STATE OF HAWAII DEPARTMENT OF TRANSPORTATION HIGHWAYS DIVISION	
GABION WALL AND APRON DETAIL	
CASTLE HILLS ACCESS ROAD Drainage Improvements, Phase 2 FEDERAL-AID PROJECT NO. STP-0300(125)	
Scale: As Shown	Date: December 2011
SHEET No. C5.1 OF C5.4 SHEETS

ADD. 17

CASTLE HILLS ACCESS ROAD
Drainage Improvements, Phase 2
Federal-Aid Project No. STP-0300(125)

SHEET No. **S14** OF 17 SHEETS

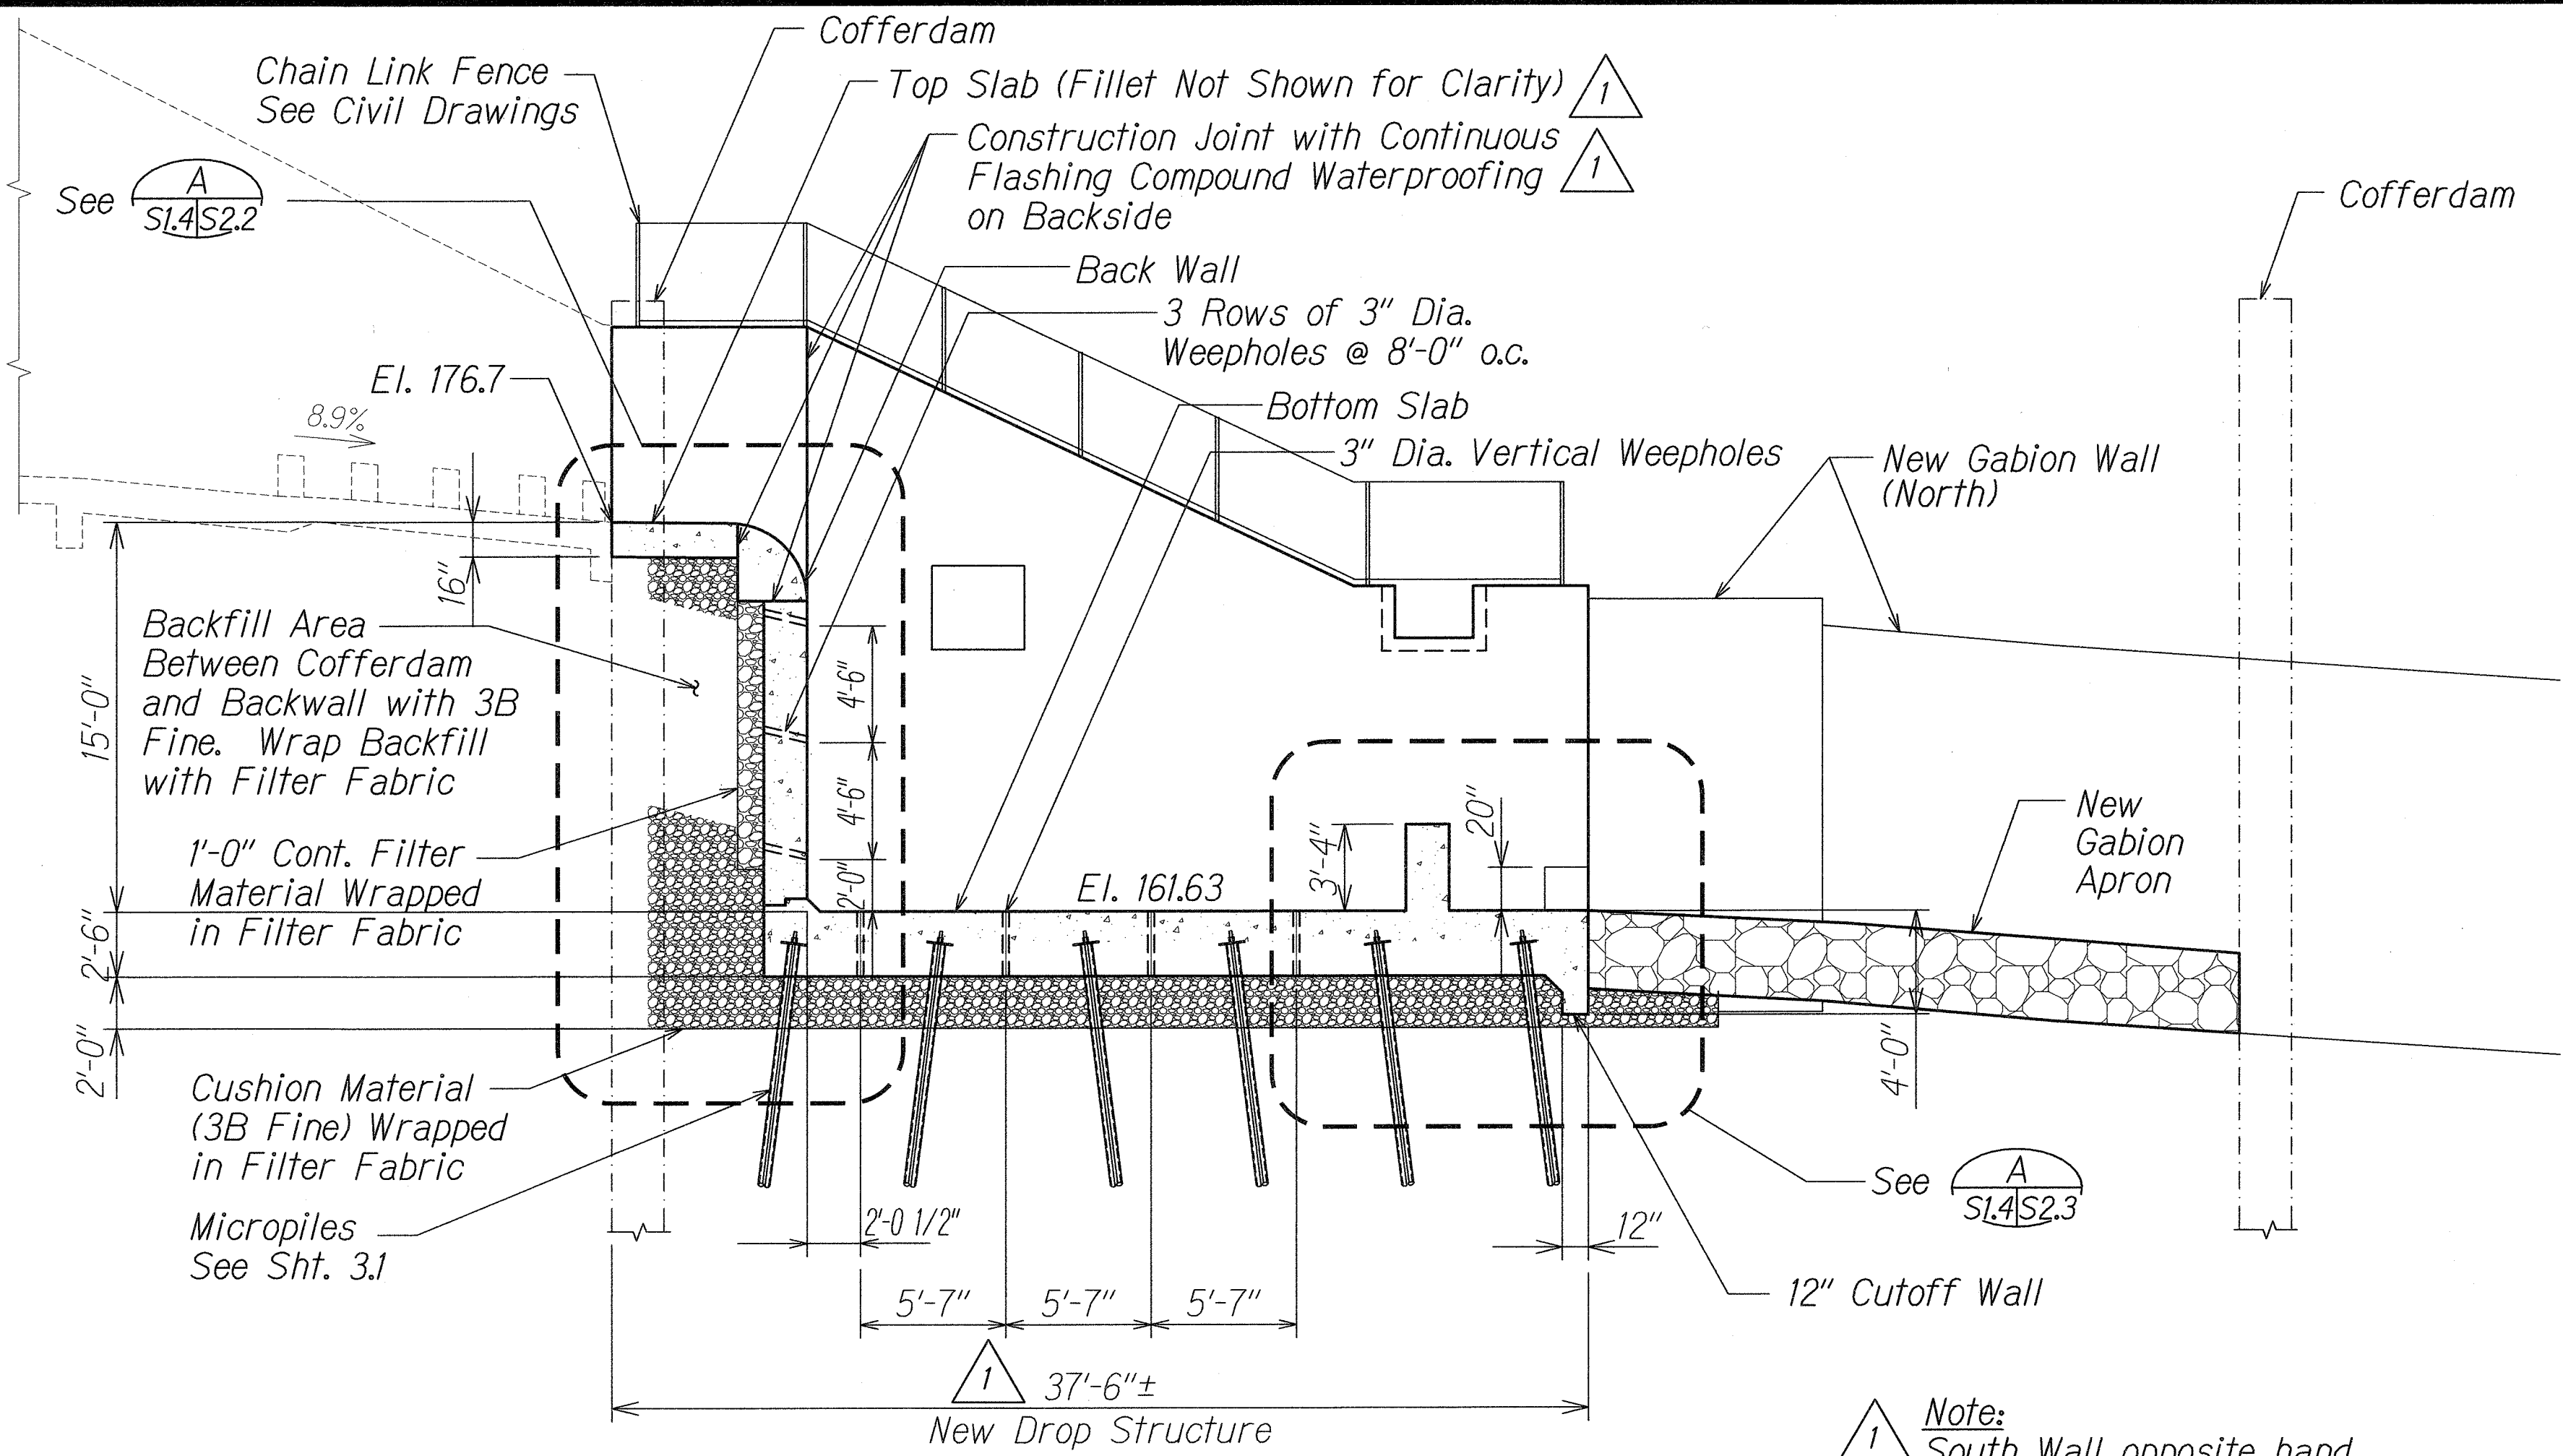
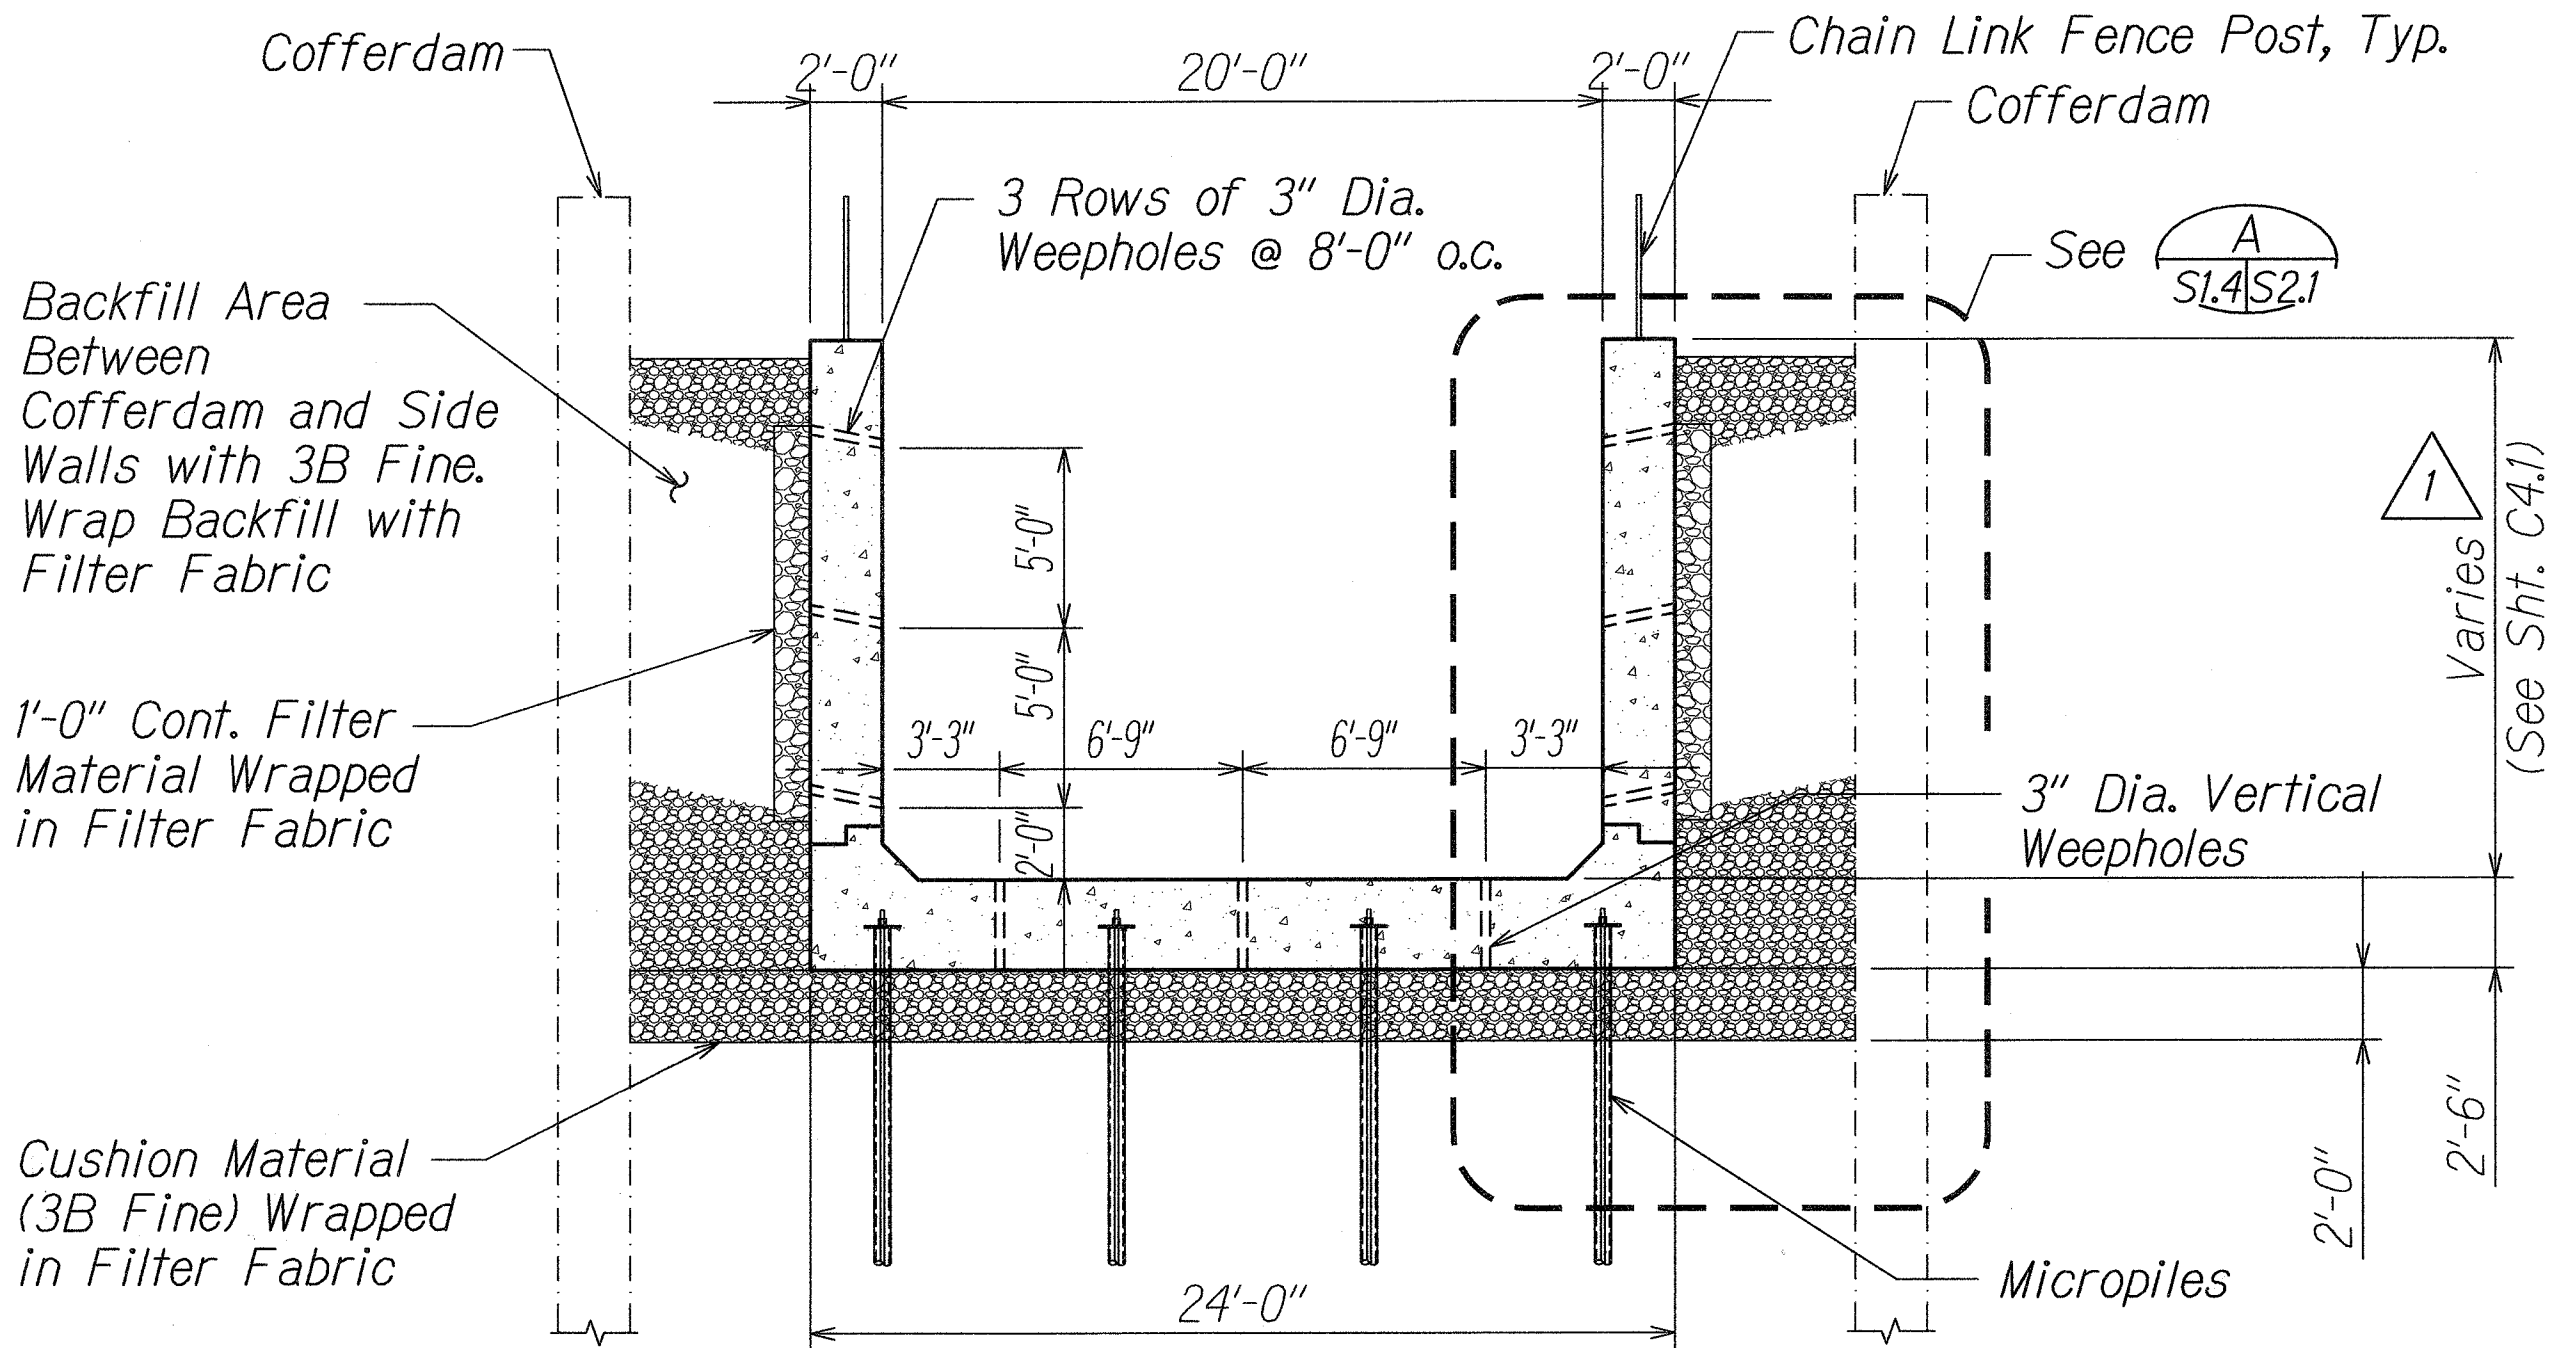
01/19/12	Added Construction Joint. Note Clarification.
DATE	REVISION

SHEET No. S2.2 OF 17 SHEETS

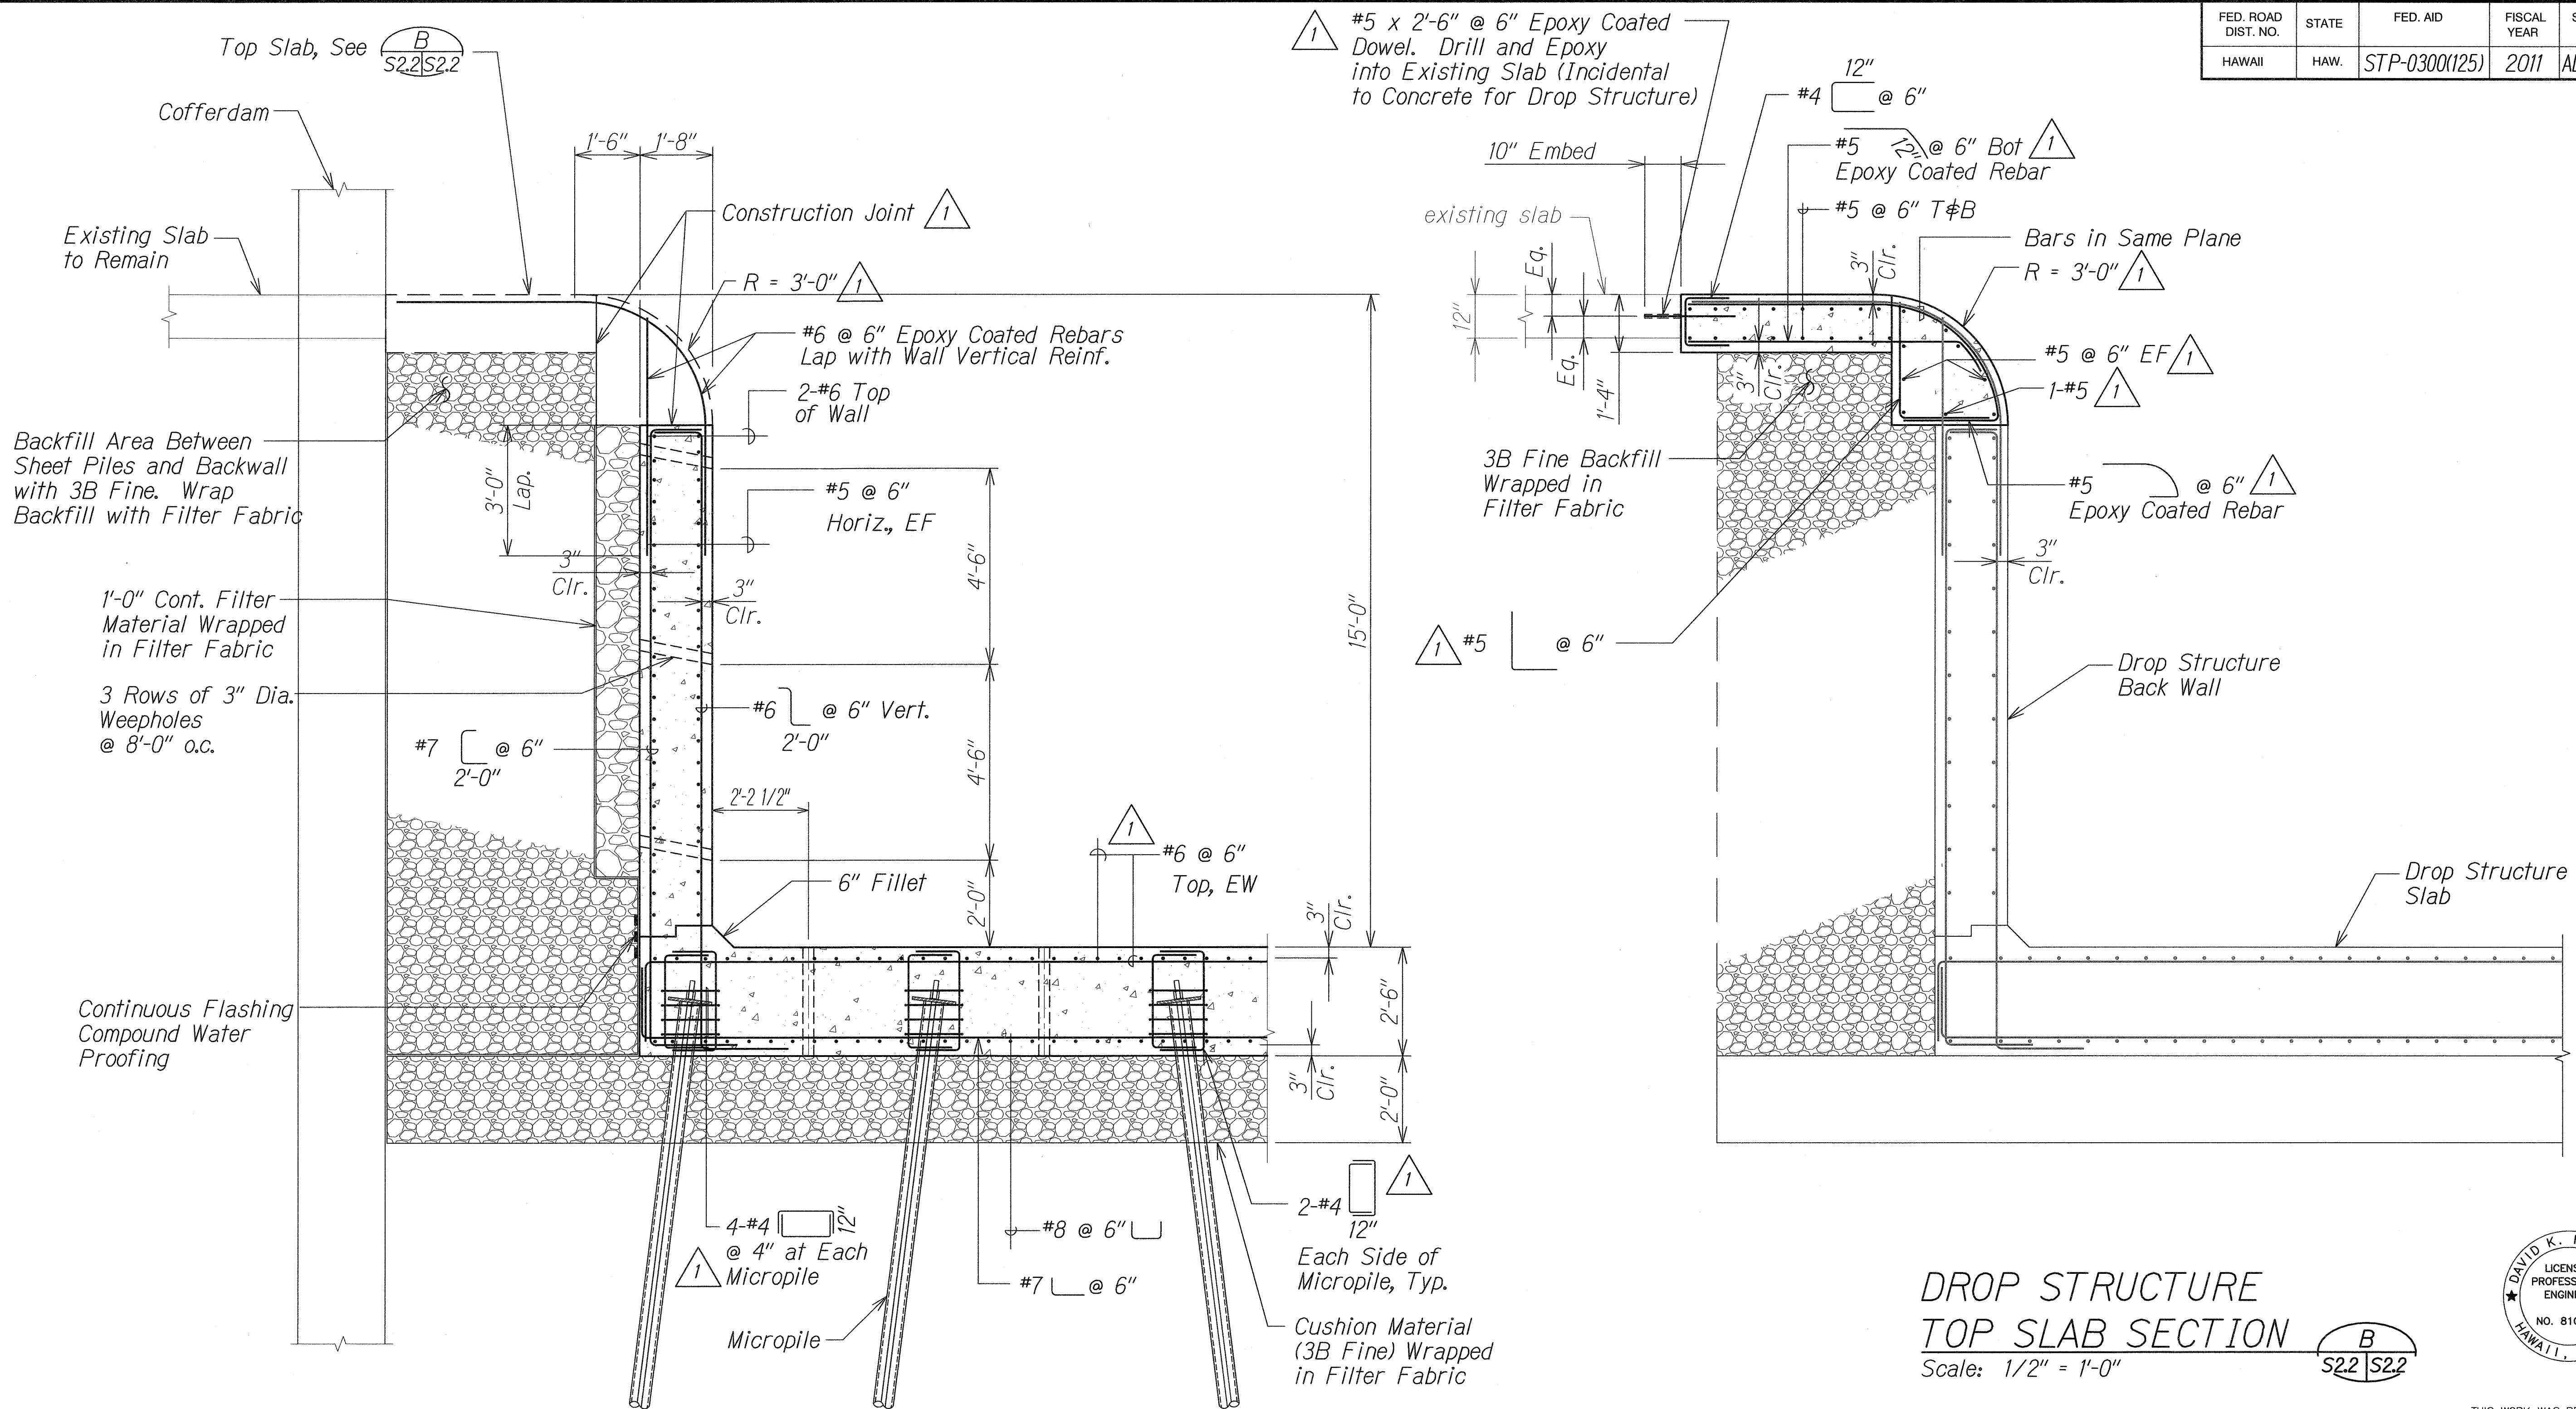
01/19/12	1	Clarified Notes. Added Construction Joint. Revised Reinforcing
DATE	REVISION
